**EXPLANATION OF SIGNIFICANT DIFFERENCES  
FOR THE 300-FF-2 OPERABLE UNIT RECORD OF DECISION**

May 2004

USDOE Hanford 300 Area  
300-FF-2 Operable Unit  
Hanford Site  
Benton County, Washington

Figure 1. 300 Area Waste Site Groups Identified for Unrestricted Use Cleanup.

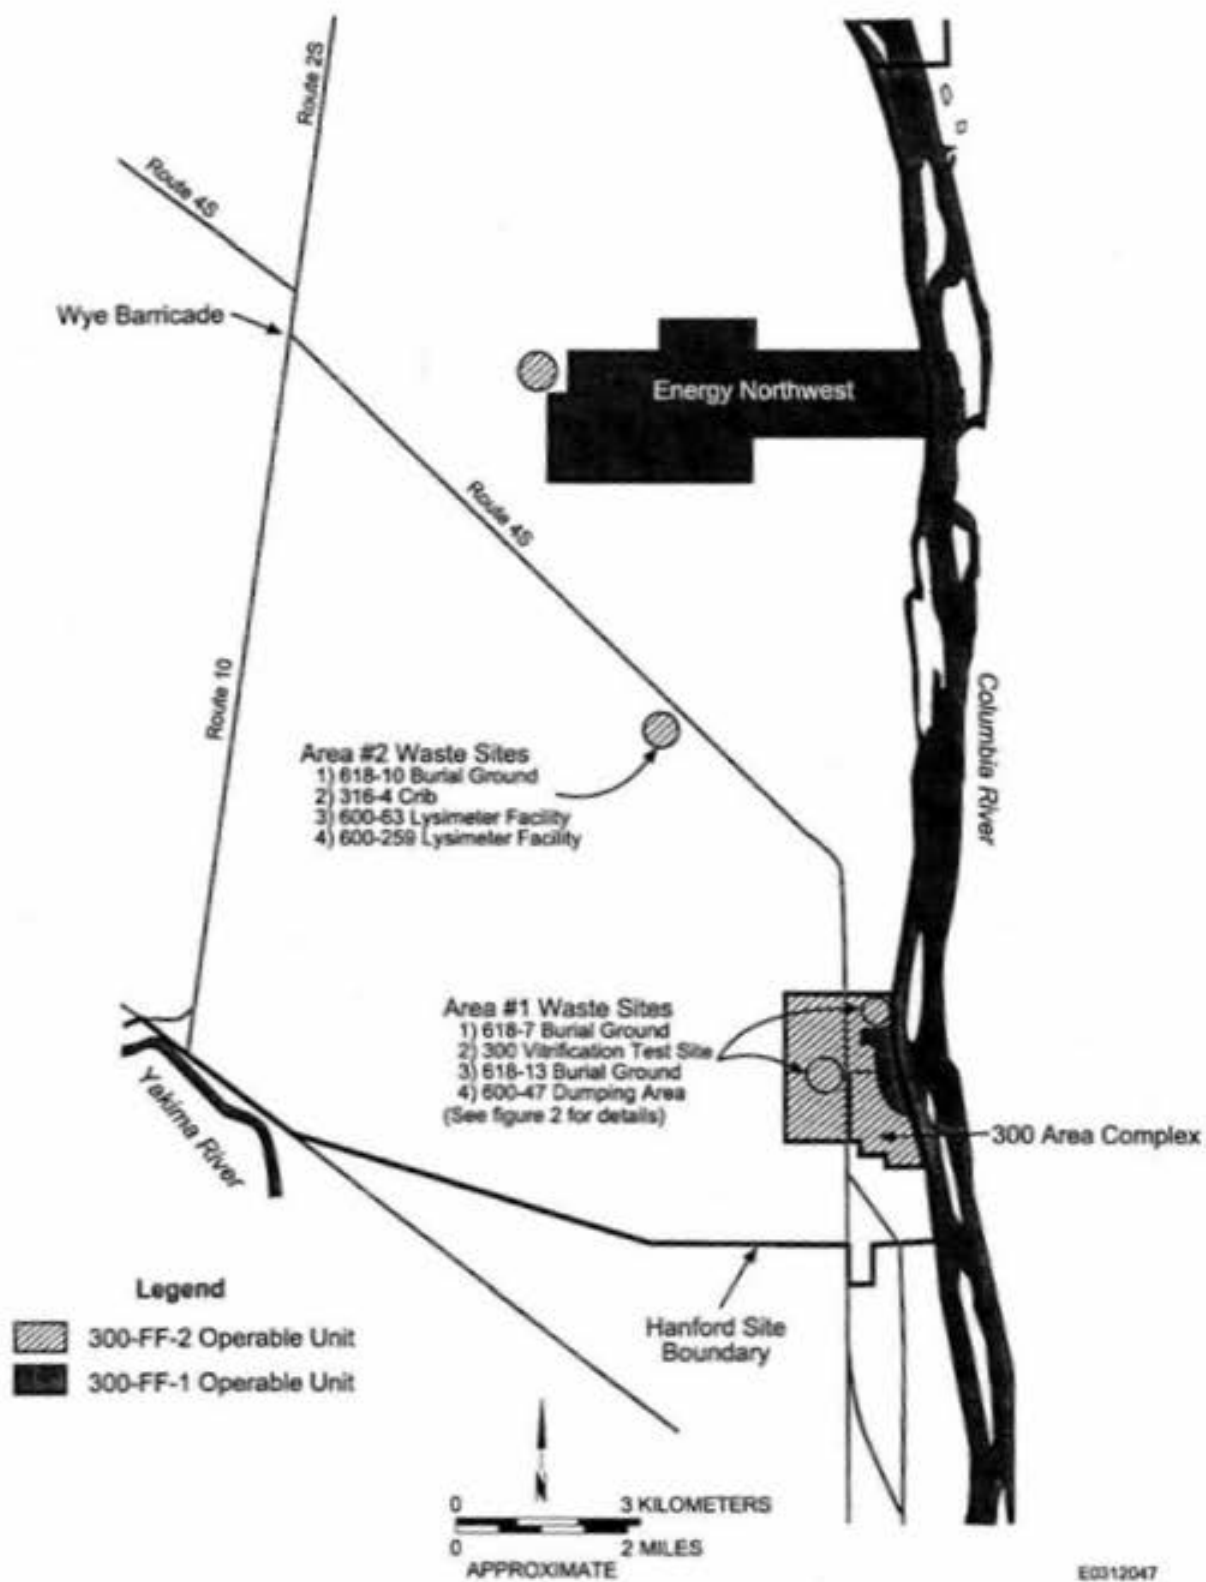
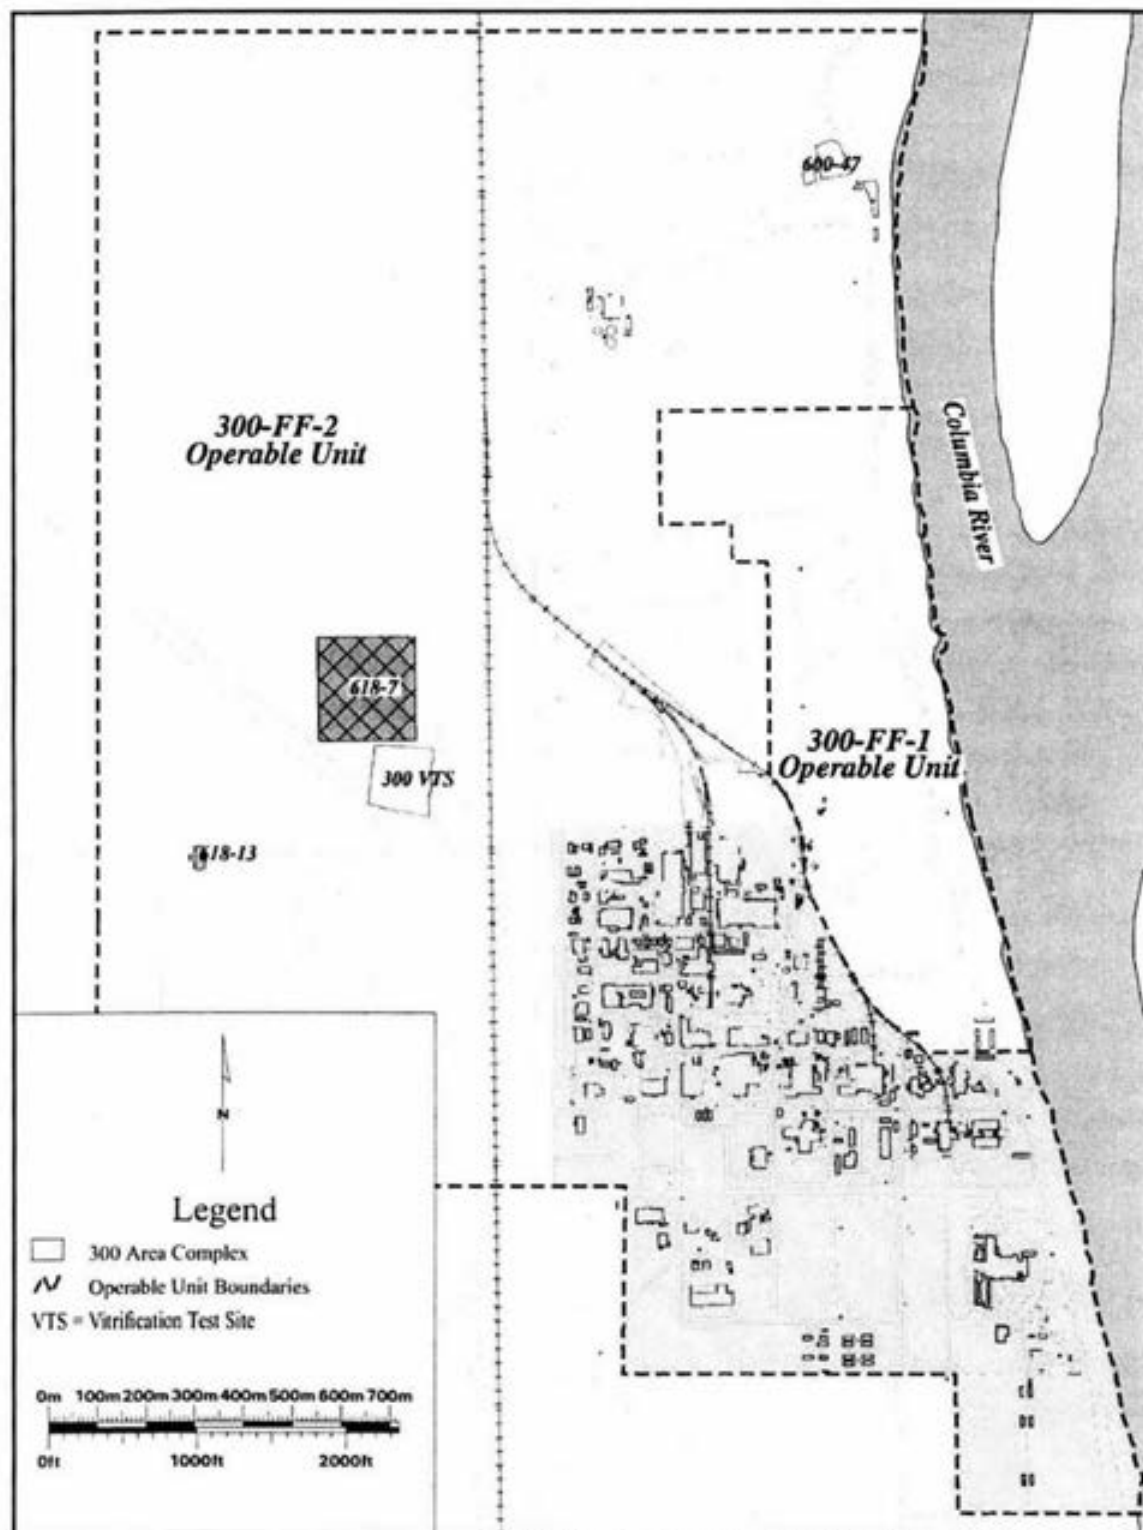
**Change 2:** Modify the soil cleanup levels for eight outlying waste sites. The 300-FF-2 ROD concluded that the reasonably anticipated future land use would be industrial for the entire 300-FF-2 Operable Unit (OU), which was based on available land-use planning documents and was the basis for the industrial cleanup levels. Further evaluation by the Tri-Parties concluded that a change in cleanup levels would be appropriate for eight specific outlying waste sites in order to reduce the long term costs of institutional controls and allow other beneficial uses of these outlying areas. The location of these waste sites is depicted in Figure 1 and Figure 2. The revised cleanup levels are based on the 100 Area rural residential exposure scenario, commonly referred to as unrestricted, and are listed in Tables 1 and 2.

In addition, the Tri-Parties have agreed that unrestricted use soil cleanup levels for eight waste sites would be appropriate in the 300-FF-2 OU, that are located outside the 300 Area "core industrial zone area" (see Figures 1 and 2). An ESD is necessary to change the cleanup levels for these eight specific outlying waste sites.

The key assumptions in the 300 Area unrestricted land-use scenario that affect the groundwater protection determination are irrigation at agronomic rates (76 cm/yr [30 in./yr]), surface vegetation resulting in an evapotranspiration coefficient of 91%, and the change in the exposure pathway to include drinking water ingestion. Based on the unrestricted land-use scenario described above, the cleanup levels to be used for the eight waste sites are listed in Tables 1 and 2.

**Figure 3. Solid Waste Uranium Groundwater Protection Assessment Model.**

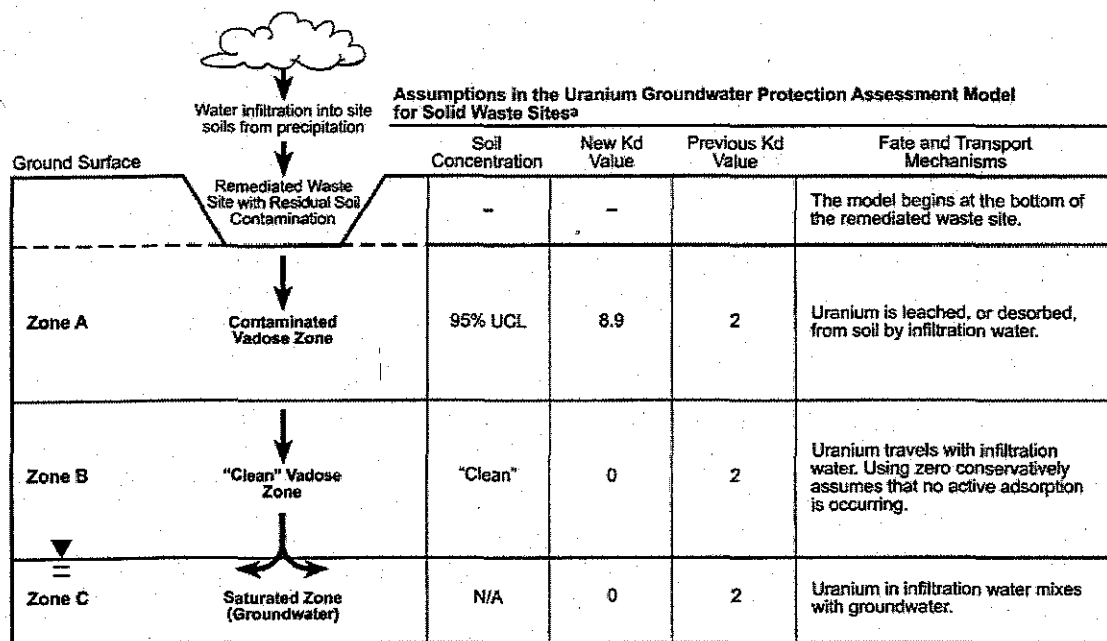
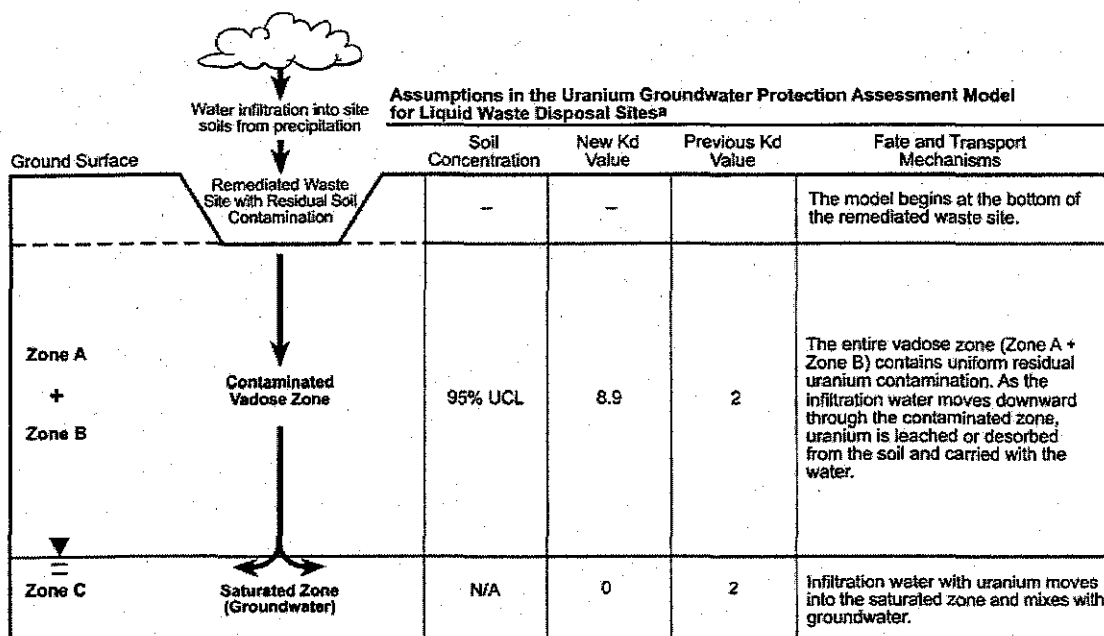
The old and the new conceptual models are shown in Figures 3 and 4.

A revision has been made to the conceptual site model (see the "Analysis of Results and Revision of Conceptual Site Model" section for a description of the old and new conceptual models), which is used to evaluate compliance with the RAOs specified in the 300-FF-2 ROD (EPA 2001) for cleanup actions to be protective of groundwater and surface water quality. The change is to use  $K_d$  values and a revised conceptual site model that is representative of the observations made during the PNNL leach test/ $K_d$  study (PNNL 2002).

A RESRAD assessment of site-specific residual uranium soil concentrations for groundwater protection was performed using new  $K_d$  values (8.9 mL/g for the contaminated zone, 0 mL/g for the uncontaminated zone, and 0 mL/g for the saturated zone). In addition, the approaches developed in the *Remedial Design Report/Remedial Action Work Plan for the 300 Area* (RDR/RAWP) (DOE-RL 2002b) for cleanup verification of solid and liquid waste disposal sites were also applied. The RESRAD calculations used the applicable land-use scenario (industrial, without irrigation), soil characteristics, and hydrogeologic inputs. The model calculated the concentrations in groundwater, and then these concentrations were compared to the drinking water standard maximum contaminant level (MCL) of 30  $\mu\text{g/L}$  (20.8 pCi/L) for making decisions on whether residual contamination levels are protective of groundwater. The model predicts that 267 pCi/g of uranium in soil is protective of groundwater at the drinking water MCL standard and of the Columbia River.

The soil cleanup level for uranium for the 300 Area industrial waste sites will be changed from 350 pCi/g to 267 pCi/g (see Table 3). The basis for this change is RESRAD modeling to predict the residual uranium soil contamination that will not cause an exceedence of the groundwater
